Subject: RE: City Hydrology Letter For the Grading and Drainage Plan for 11301 San Antonio (D22/D001),

#### GRADING & DRAINAGE PLAN

Re: Lot 19, Block 20, Tract 2, Unit 2, North Albuquerque Acres 11301 San Antonio Dr. NE Grading and Drainage Plan Engineer's Stamp dated 6-07-13 (D22/D001)

## County of Bernalillo Case Comments Report

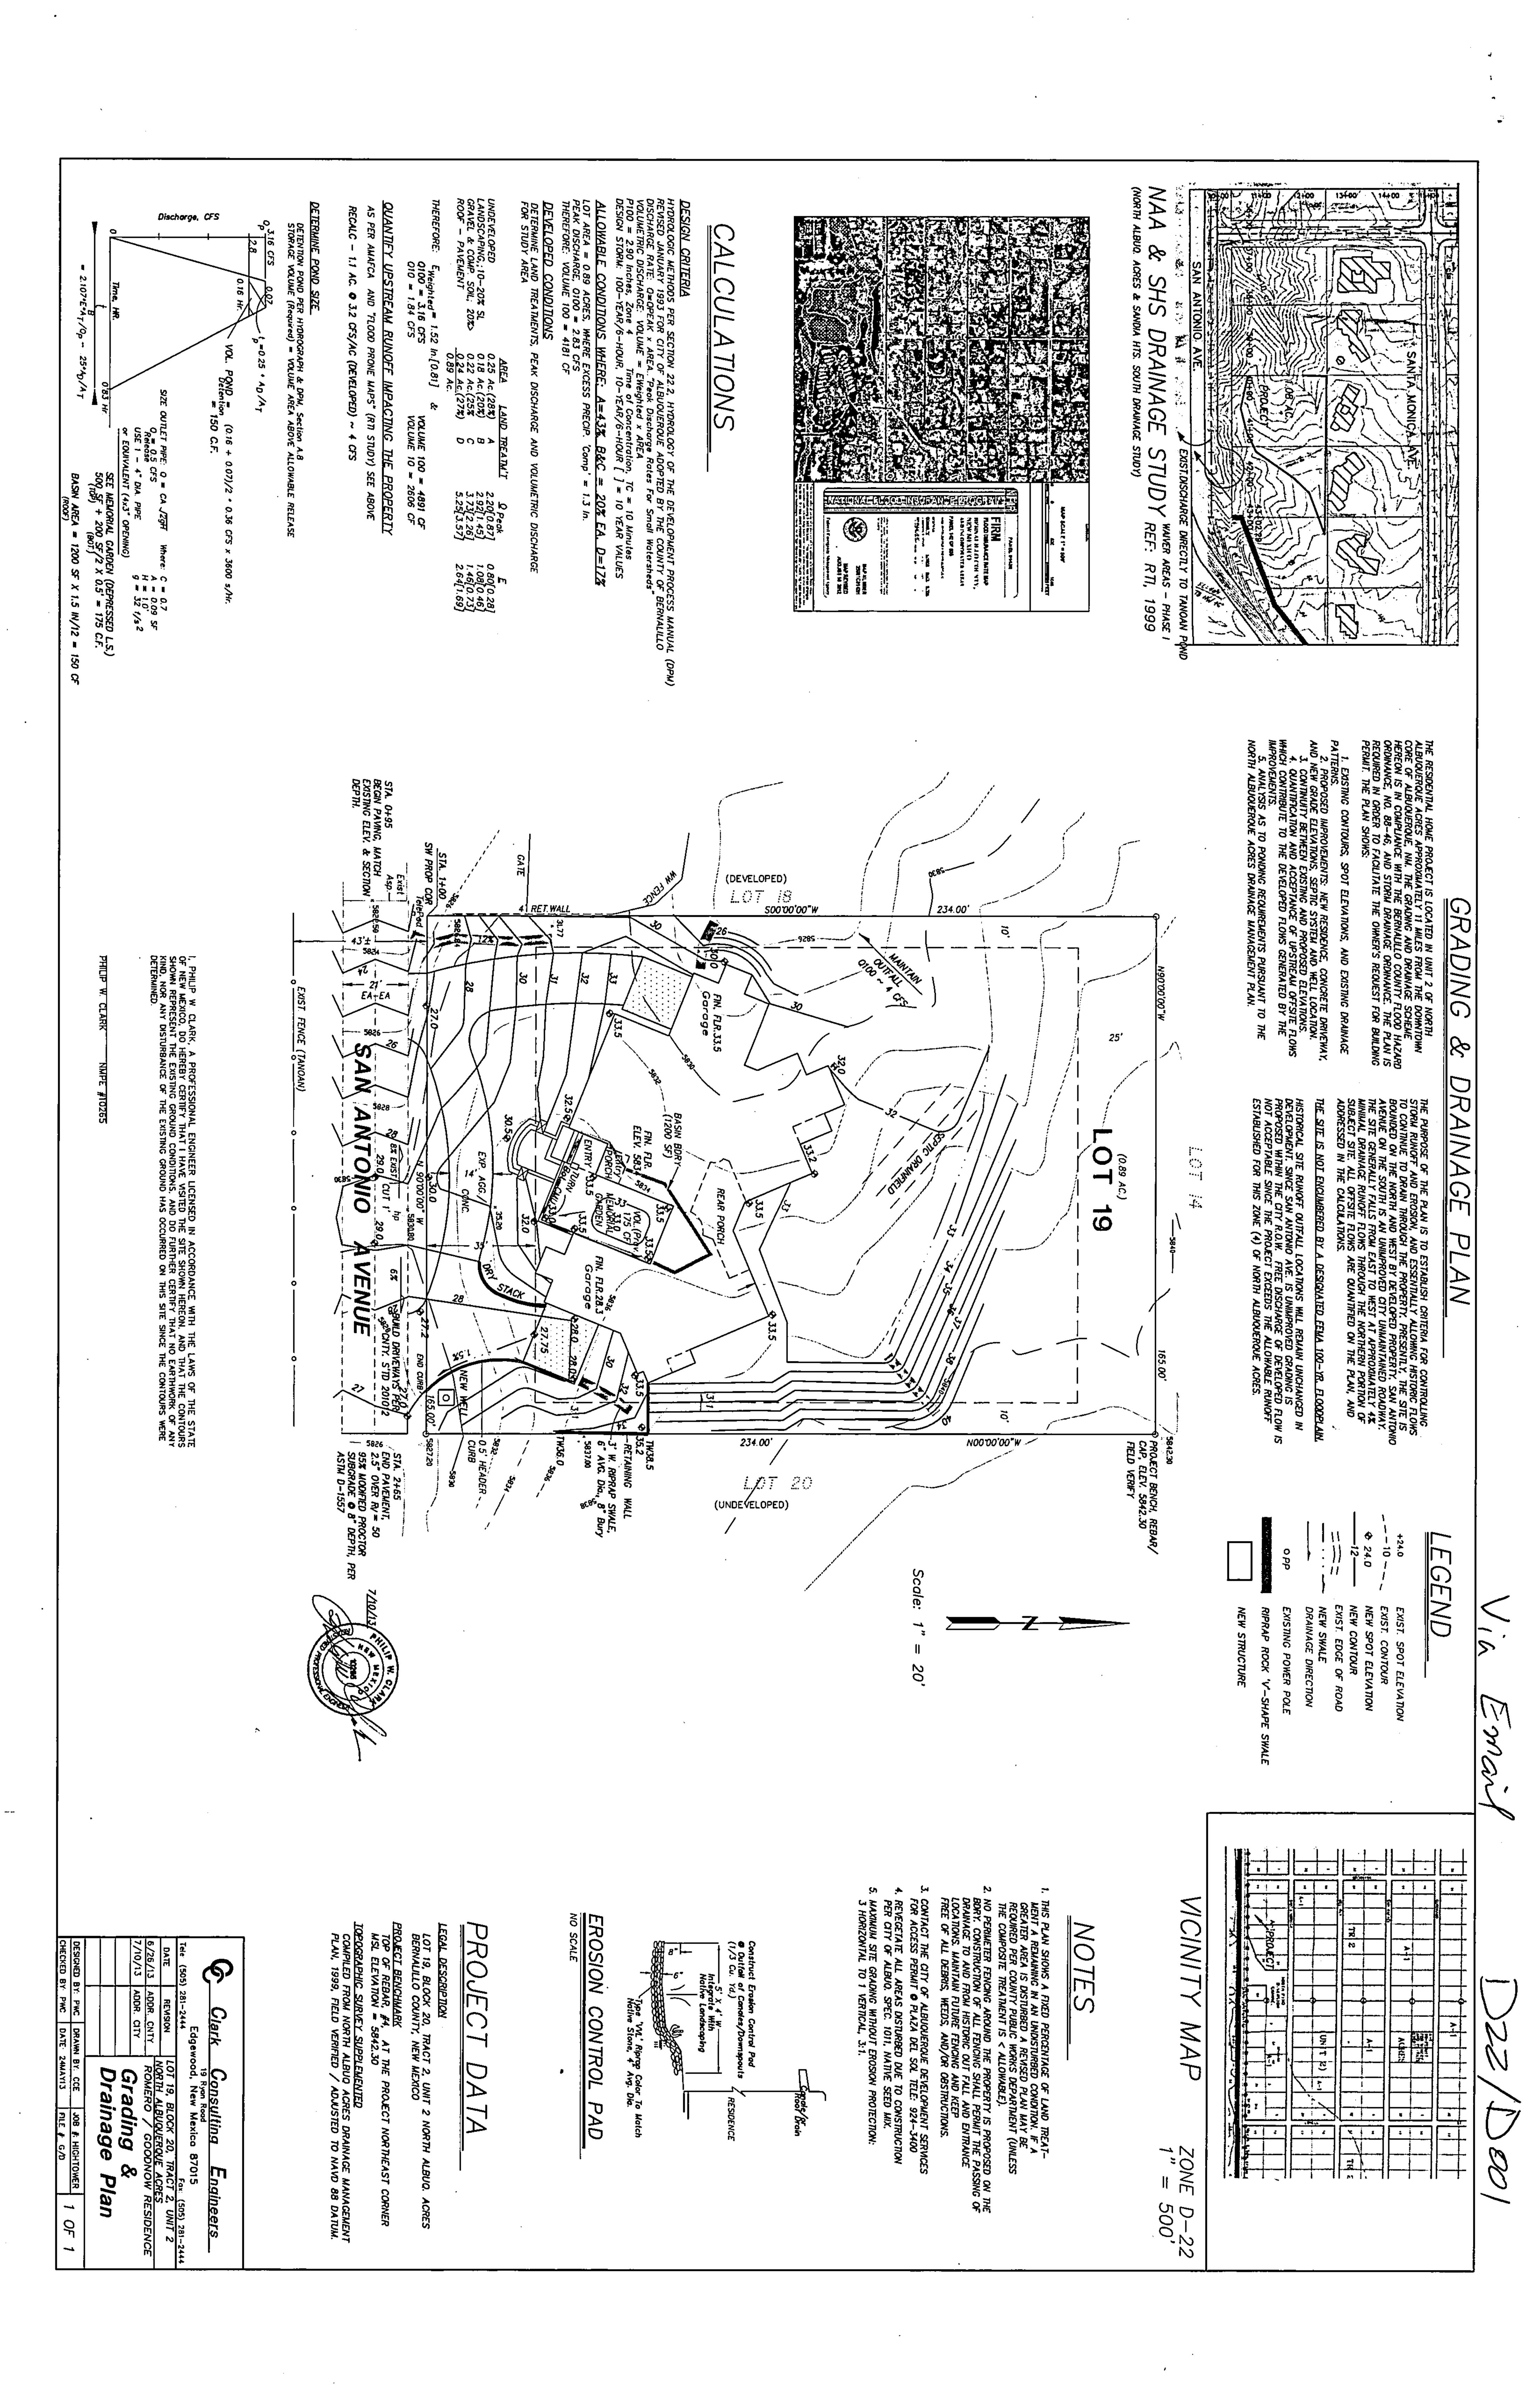
• Any work on San Antonio should be submitted and approved through Design Review Committee (DRC) and constructed through the work order process. The driveways must be constructed under the work order. Curb and gutter and sidewalk may be required.

• In most cases the entire site is disturbed as part of clearing and grubbing. Therefore, under the developed conditions Treatment A=0%.

- Please double check the "D" treatment. It appears that the D treatment is more than 27%. Clearly show all the concrete work around the pool area and other walkways.
- It is not clear how and how much runoff will drain to the proposed detention pond. Show the 4" pipe.
- A desilting pond may be required at the east end of the San Antonio Dr.

How will the septic system be accessed? A retaining wall may have to be constructed along the westerly boundary to create the necessary access to the back. Mr. Clark, July 9, 2013 Page 2

- 7 cfs is shown to drain to Lot 18. Does this flow include the developed runoff from the back of the house? We recommend that the 7 cfs to be routed south to San Antonio. Provide more spot elevation around the pool area and the back of the house. Provide an offsite drainage basin and calculations.
- Total disturbed area included the road work will be more than one acre. Therefore, SWPPP will be required.

1) Please provide FEMA Flood Insurance Rate Map the shows the relationship of the proerty to the nearest flood zone.

2) Indicate on the plan the the driveway access points are to be constructed as per Standard Drawing 201012.

3) Plan must show adequate basin area to provide required detention volume to memorial garden. Pond volume calculation assumes the whole site runs through the detention pond.

4) Show pond discharge pipe and associated inverts on the plan.

5) Indicate the 33 contour location in backyard.

1st bullet - Work Order for San Antonio, I spoke with Moncia O. and according to her the two neighbors to our west were not required to go to Work Order. As discussed with you, this may be that the non-st'd roadway was extended as temporary - 21-22' paved width, without curb/gutter nor sidewalk, within a non-standard Right-of-Way (measured 43 feet) from the north R.O.W. to the Tanoan improvements (permanent-type fencing).

- 2/8 The plan shows 1/4 of the 0.88 lot remaining undisturbed, and is not to be stripped of natural vegetation during clear/grub operations. Additionally, please note that any soil disturbed must be revegetated to City spec. 1011 per note 4. A SWPPP, therefore should not be required.

- 3 I checked the 27%(D) and it calced correctly The pool and deck has been deleted.
- 4 The pond calcs are clarified, and will spill out the Turned CMU (equiv. alternate to 4" pipe)

- 5 A small, appropriately sized desilting pond could be incorporated during construction although is not recommended.
- 6 Septic Access According to Alpha Septic, an intermediate pump is/can be employed in longer runs for maintenance operations.

- 7 Upstream basin calculation is verified/reduced in the calcs section + see plan upper left corner. As discussed this plan is within the previous overall study provided by RTLto the County back in 1999. Maintaining historic flow paths are preferred in the County. From my experience, even slight diversions as you suggested should be discouraged. The current County review fee in NAA is 220\$ and continues to pay for/reimburses the cost of this study.
